ALASKA STATE LAND SURVEY NO. 85-109
 Plat #87-7
 Sec. 36 T9S R9W & Sec. 31 T9S R8W FM
 Nenana
 9/28/88
 ALASKA STATE LAND SURVEY #85-109
 Plat #87-7
 Sec. 36 T9S R9W & Ptn. Sec. 31 T9S R8W FM
 Nenana
 5/26/87

AMENDED PLAT

ALASKA STATE LAND SURVEY No. 85-109
 WITHIN
 SURVEYED SEC. 36, TRACT-A, T9S., R.9W., FM., ALASKA
 SURVEYED SEC. 31, T9S., R.8W., FM., ALASKA

Plat title, ASLS 85-109

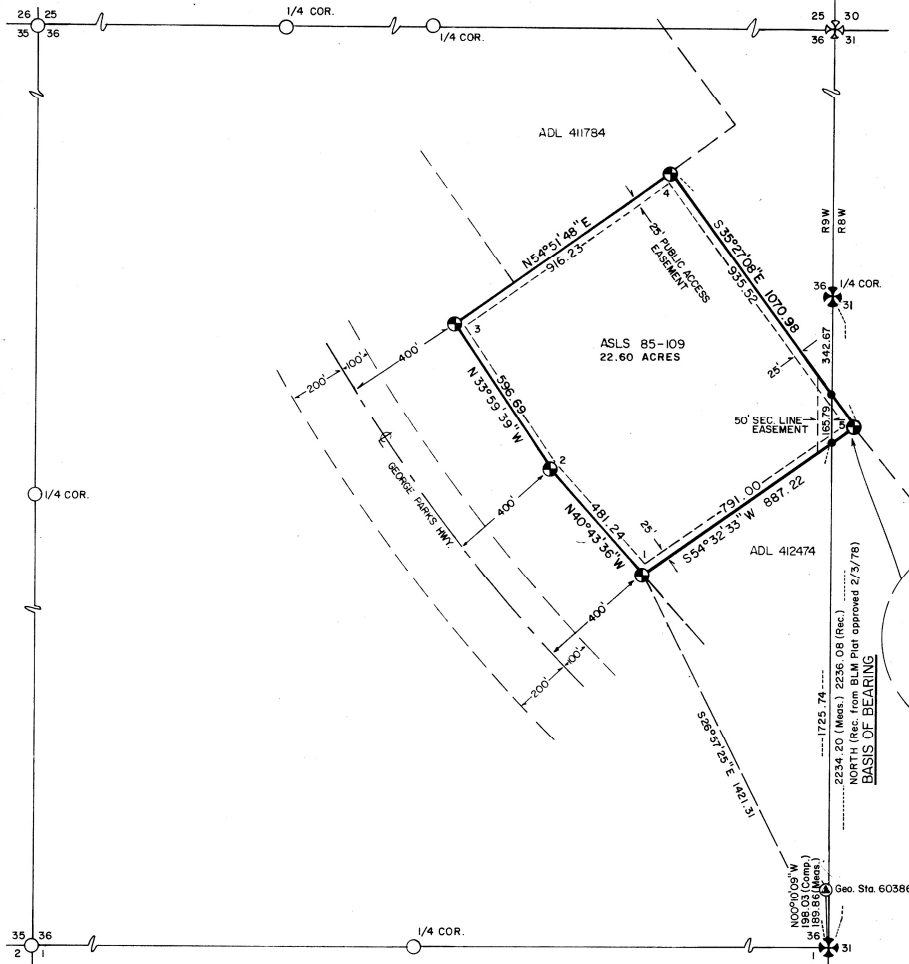
Date	Correction	Checked
6/87	Corrected bearings & distances around tract boundary and tie to Basis of Bearing. Moved intersection monuments on to Range line.	ML

Corrected Bearings and Distances around tract boundary and to the Basis of Bearing. Show correct location of section line intersection monuments.
